PLANNING COMMISSION
STAFF REPORT – DECEMBER 18, 2013
CASE NUMBER: DP-13-0732
Case Manager: Dawn Wrinn, CAPZO

Project Name:	Parking Plan
Property Address:	504 Dusy Street
Requested Action:	Development Plans
Applicant:	Johnson & Reeves Engineering representing
Property Owner:	Dothan City Board of Education

PLANNING COMMISSION
STAFF REPORT – DECEMBER 18, 2013
CASE NUMBER: DP-13-0785
Case Manager: Dawn Wrinn, CAPZO

PLANNING COMMISSION
STAFF REPORT – DECEMBER 18, 2013
CASE NUMBER: DP-13-0788
Case Manager: Dawn Wrinn, CAPZO

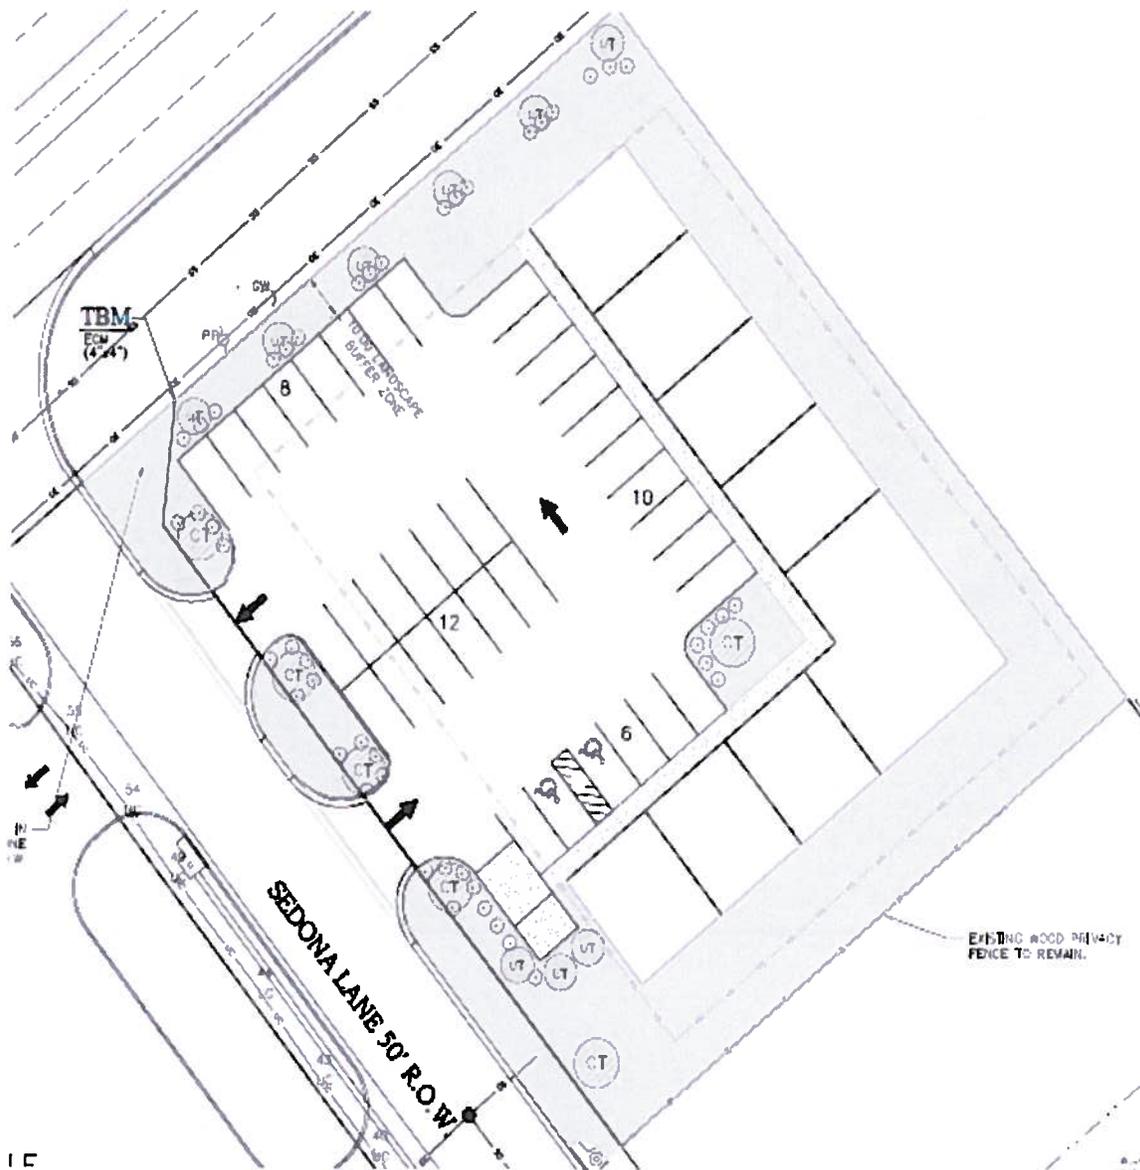
Buffers: There is an existing wood privacy fence along the rear property line adjacent to the residence that is shown to remain. A Type 2 buffer is required, 25 feet wide with 8 trees and 30 shrubs per 100 linear feet.

Parking: Parking areas must be a minimum of 10 feet behind the street right-of-way. This has been done as shown above.

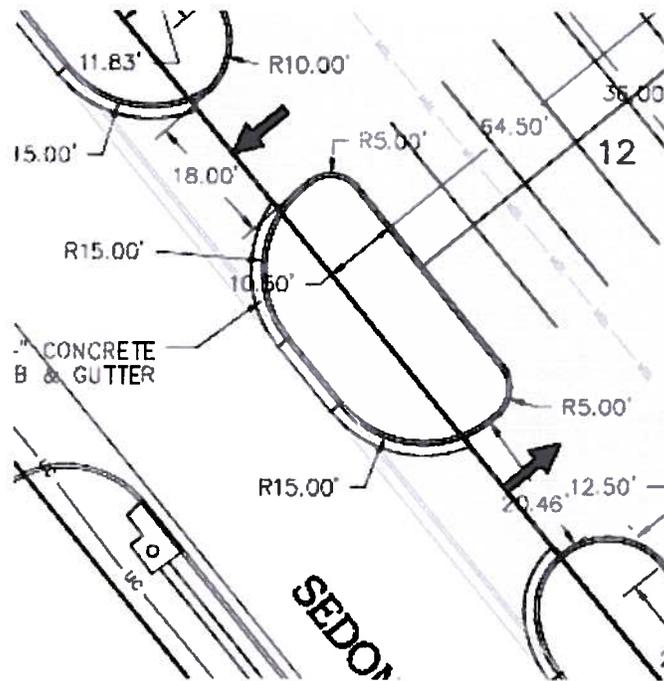
Both driveways shall be widened to a minimum of 24' feet in width to allow bi-directional traffic.

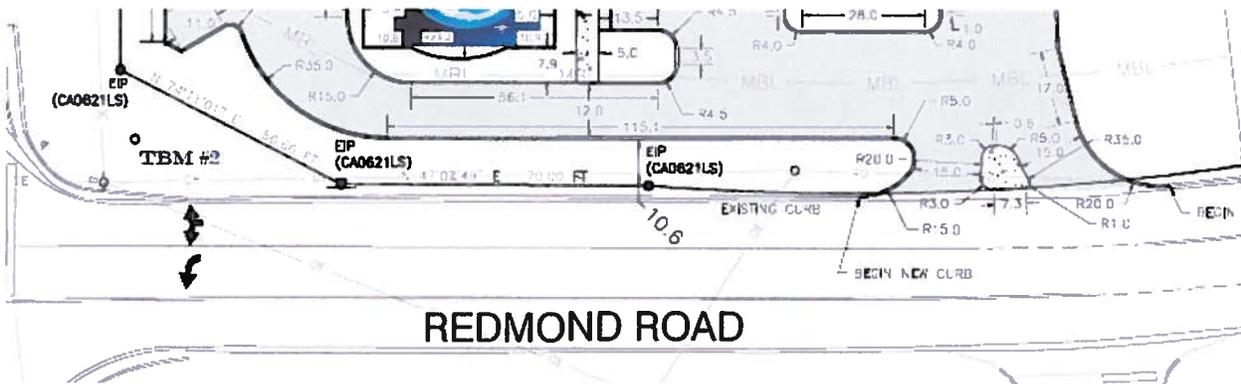
The south driveway, adjacent to Redmond Road, shall be a right-in/right-out with a raised concrete island and designed in such a way to minimize the possibility of motorists making a prohibited movement to either ingress or egress the development. Signage shall include a "Do Not Enter" (facing Redmond Road) and a "No Left Turn" (northbound on Redmond Road). A thermoplastic right turn arrow pavement marking shall be placed near the raised concrete island to direct motorists egressing the property

The size and shape of the raised concrete as well as the sign posts and signs used shall meet City requirements.
